CITY OF LEWISTON
PLANNING BOARD MEETING
Monday, August 27, 2012 – 5:30 P.M.
City Council Chambers – First Floor
Lewiston City Building
27 Pine Street, Lewiston

TO: Planning Board
FROM: David Hediger, City Planner
DATE: August 23, 2012
RE: August 27, 2012 Planning Board Agenda Item IV(A)

An application submitted by Sebago Technics, Inc. on behalf of Central Maine Medical Center to consolidate and pave their existing parking areas located at the intersections of Main Street, High Street and Holland Street.

Site Plan Application: Central Maine Medical Center
Parking Lot Expansion: High Street, Main Street, and Holland Street
Response to Review Comments dated August 15, 2012

SITE / LANDSCAPE PLAN

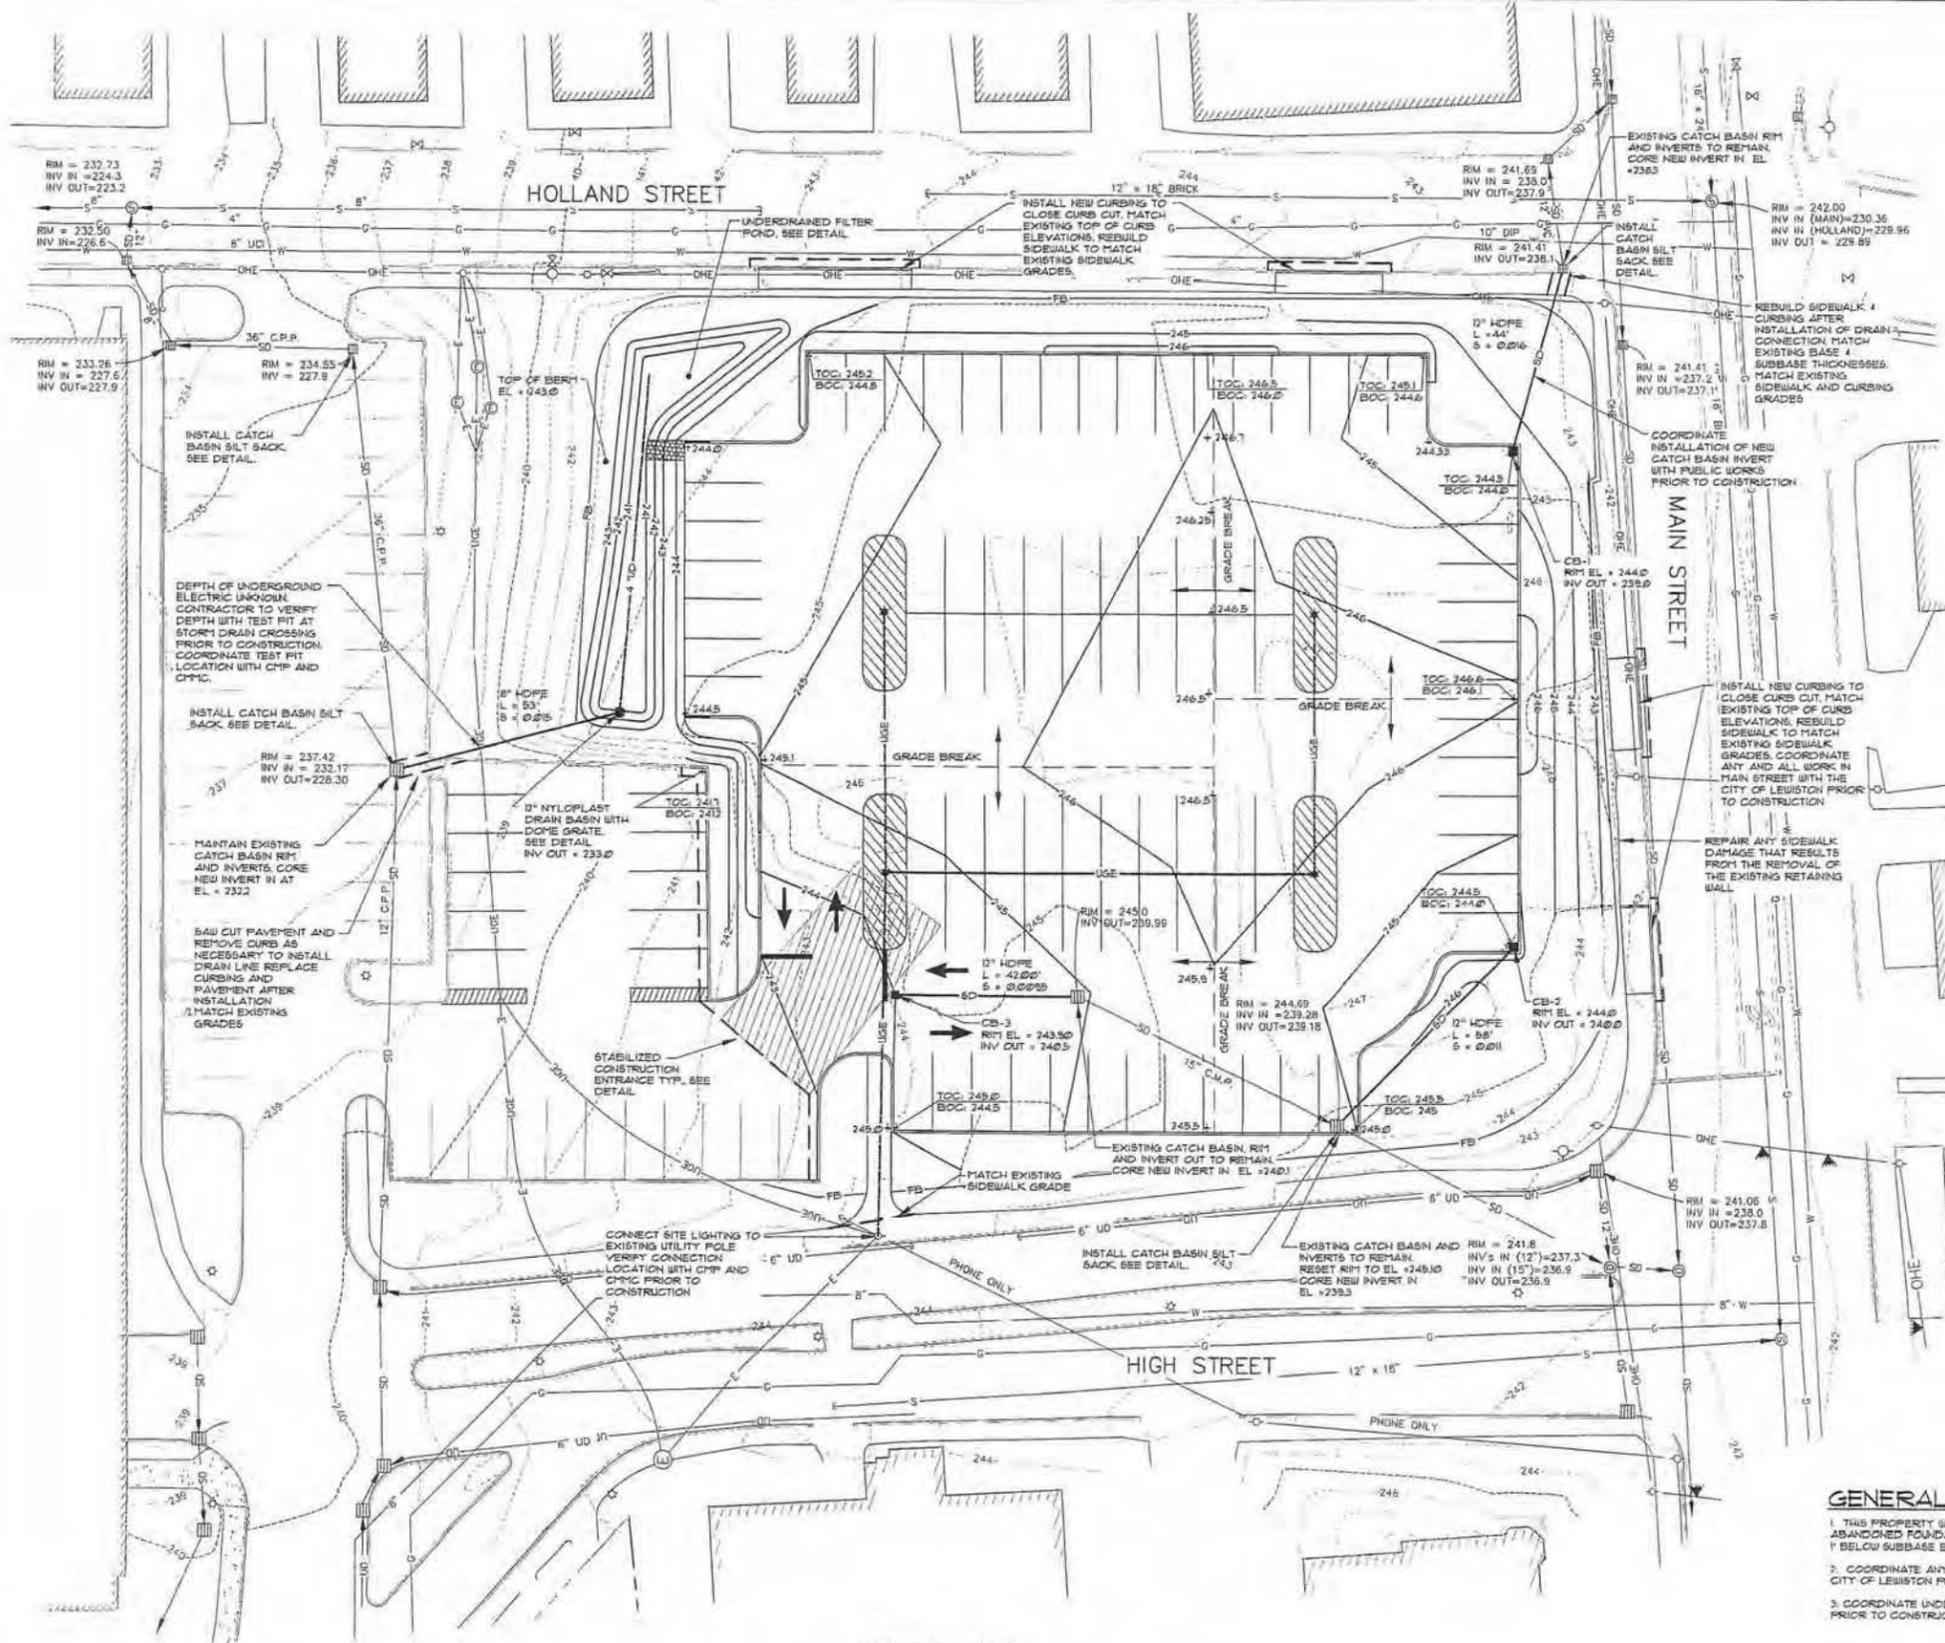
1. *Sheet 4: consideration should be given to landscaping parking lot islands that are currently proposed to be striped for no parking in effort to reduce impervious area.*

2. *Sheet 4: light poles: detail and/or note should be provided for pole height (recommended not to exceed 25' high) with cut off fixtures.*

In order to facilitate snow removal from the proposed parking area, the applicant intends to stripe the islands as proposed in the plan set.

A note has been added to Sheet 4 indicating that all light poles shall not exceed 25' in height and must also utilize cut off fixtures.

TYPICAL TRENCH SECTION
NOT TO SCALE

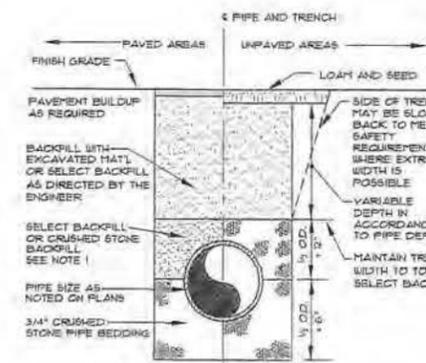
8. *Sheet 7 - Revise typical trench section to include crushed stone backfill over all pipes in the City Right of Way.*

The typical trench section has been revised to reflect crushed stone backfill over pipes in the City Right-of-Way. Additionally, a note has been added to this detail indicating the requirement for crushed stone backfill.

- NOTES:**
- ALL PIPE LOCATED WITHIN THE CITY OF LEWISTON RIGHT OF WAY SHALL HAVE CRUSHED STONE BACKFILL OVER THE TOP OF THE PIPE.

GRANITE CURB INSTALLATION
NOT TO SCALE

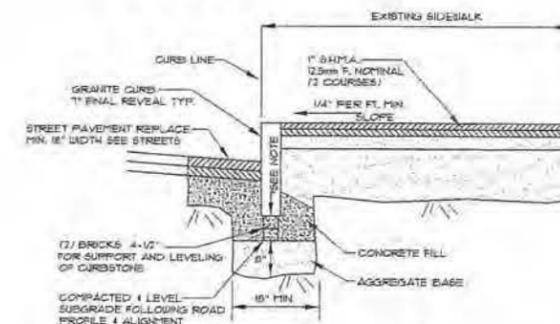
9. *Sheet 7 - Revise the vertical granite curb detail to include concrete fill around the curb within the City Right of Way.*

The vertical granite curb detail has been revised to reflect concrete fill around the curb within the City Right-of-Way.

IMPERVIOUS AREA SUMMARY PLAN

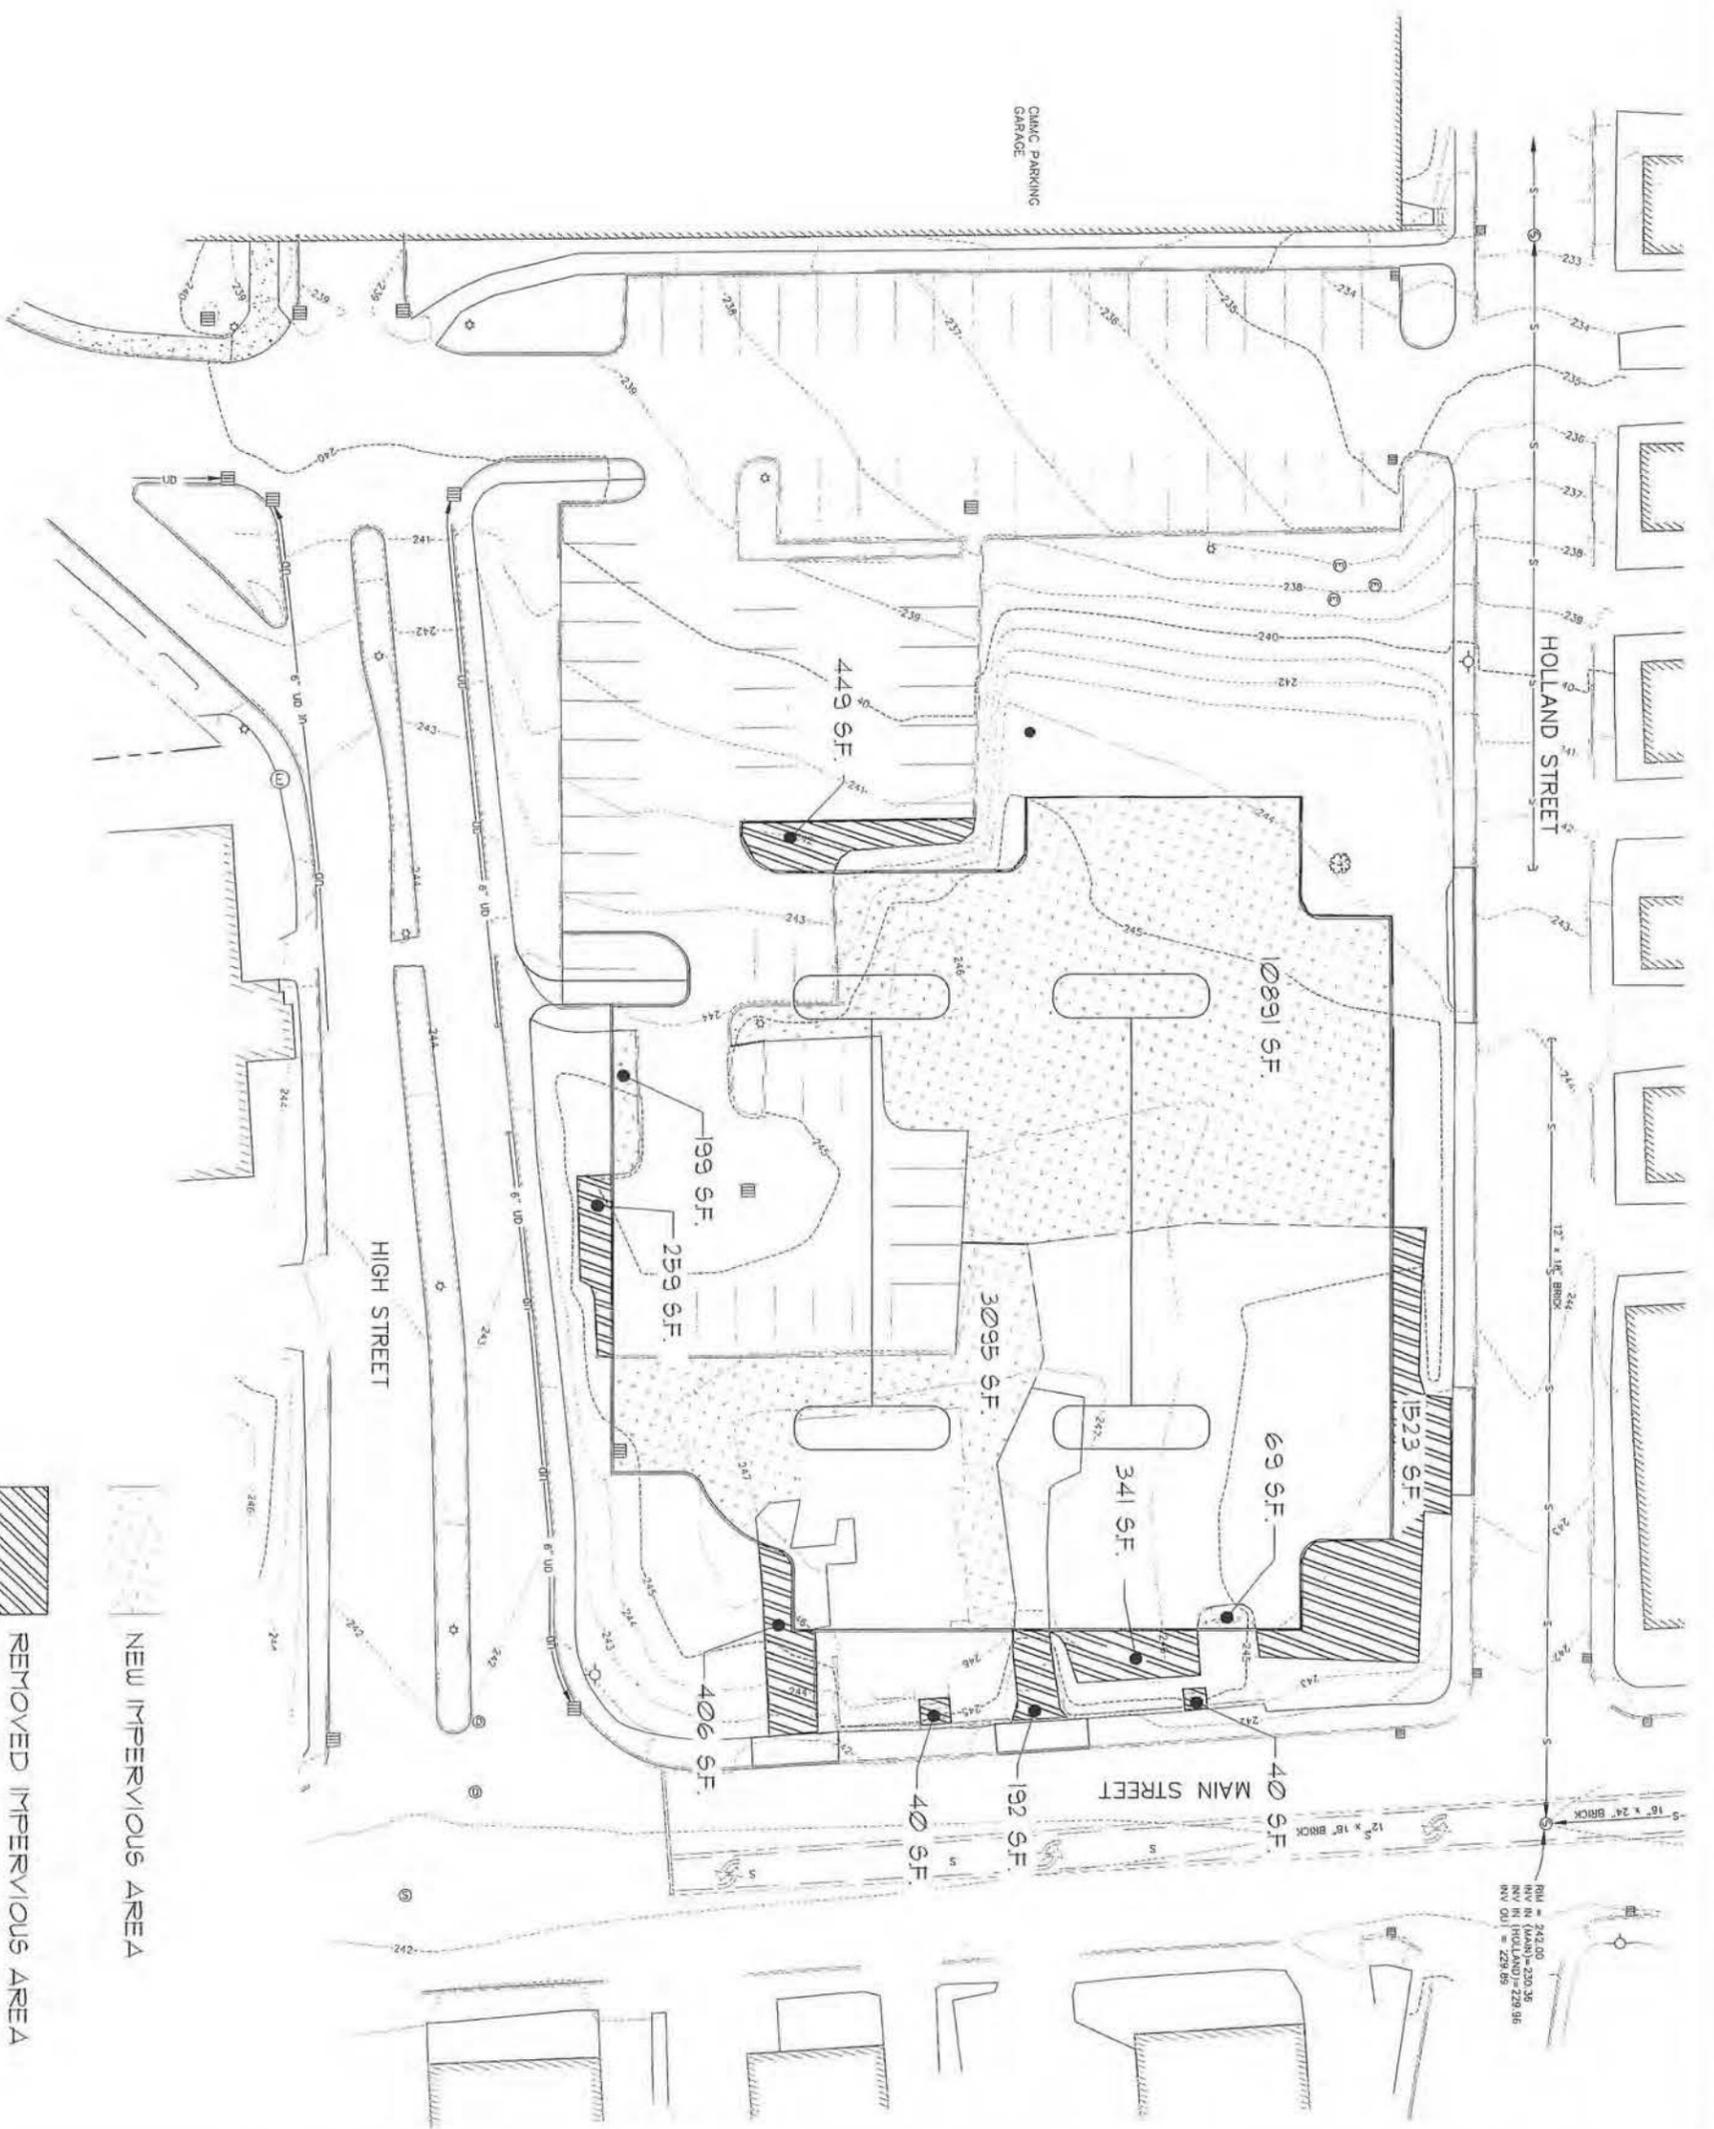
4. *Please provide a plan indicating the increase in impervious area, based on the survey plan and proposed plan it appears that the increase is greater than the 11,004 s.f. indicated.*

A plan summarizing the impervious area calculation is attached for review.

NEW IMPERVIOUS AREA = 14254 S.F.
 REMOVED IMPERVIOUS AREA = -3250 S.F.
 NET NEW IMPERVIOUS AREA = 11004 S.F.
